Notice of Intent

Sundry ID: 2823636

Type of Action: APD Change

Procedure Description: Poker Lake Unit 15 TWR 113H SUNDRY LANGUAGE XTO Permian Operating, LLC. respectfully requests approval to make the following changes to the approved APD. Changes to include SHL, KOP, FTP, LTP, BHL, Proposed total Depth, and Pool Code. There is no new surface disturbance. There is a dedicated acreage change. FROM: TO: SHL: 490' FNL & 460' FWL OF SECTION 22-T24S-R31E 510' FNL & 460' FWL OF SECTION 22-T24S-R31E 616' FSL & 1661' FEL OF SECTION 16-T24S-31E FTP: 330' FNL & 110' FWL OF SECTION 22-T24S-R31E 100' FNL & 1660' FEL OF SECTION 21-T24S-R31E LTP: 2540' FNL & 110' FWL OF SECTION 34-T24S-R31E 100' FSL & 1660' FEL OF SECTION 28-T24S-R31E BHL: 2590' FNL & 110' FWL OF SECTION 34-T24S-R31E 50' FSL & 1660' FEL OF SECTION 28-T24S-R31E The proposed total depth is changing from 24013' MD; 10847' TVD (3rd Bone Spring Shale) to 20286' MD; 8906' TVD (Avalon). Pool Code is changing from 96403/Wildcat; Bone Spring to 96546/ Cotton Draw; Bone Spring, South A saturated salt brine will be utilized while drilling through the salt formations.

WELL LOCATION INFORMATION

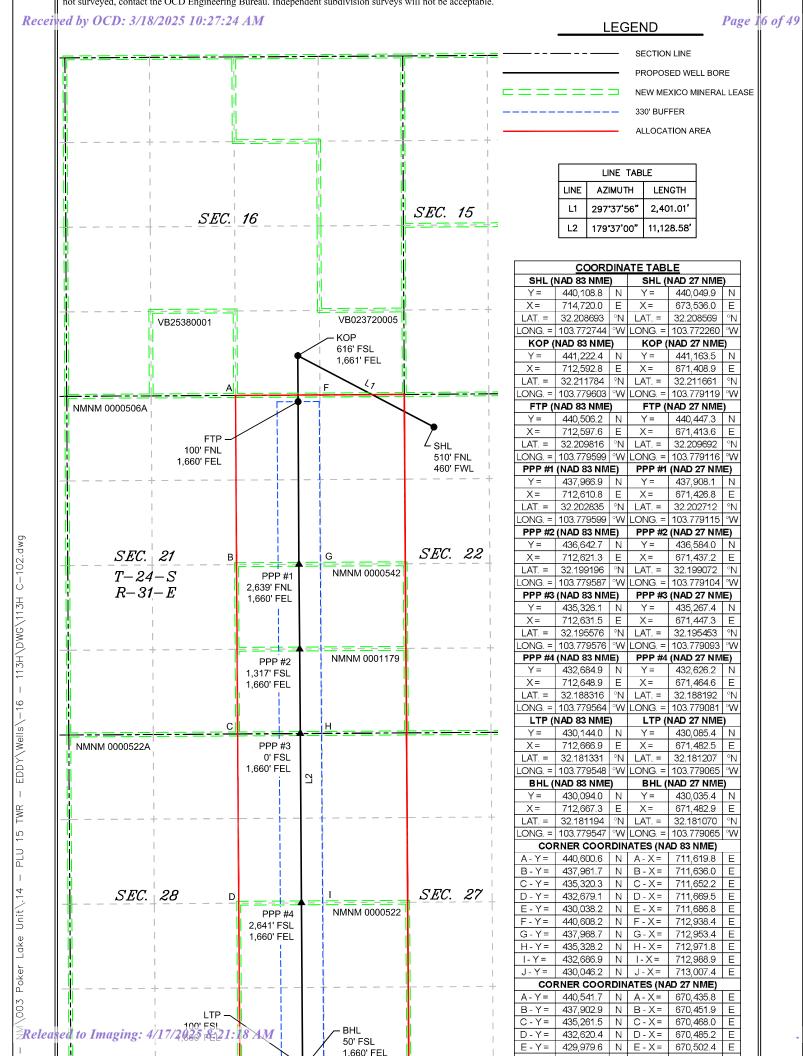
BHL: 2590' FNL & 110' FWL OF SECTION 34-T24S-R31E 50' FSL & 1660' FEL OF SECTION 28-T24S-R31E

The proposed total depth is changing from 24013 MD; 10847 TVD (3rd Bone Spring Shale) to 20286 MD; 8906 TVD (Avalon).

Pool Code is changing from 96403/Wildcat; Bone Spring to 96546/ Cotton Draw; Bone Spring, South
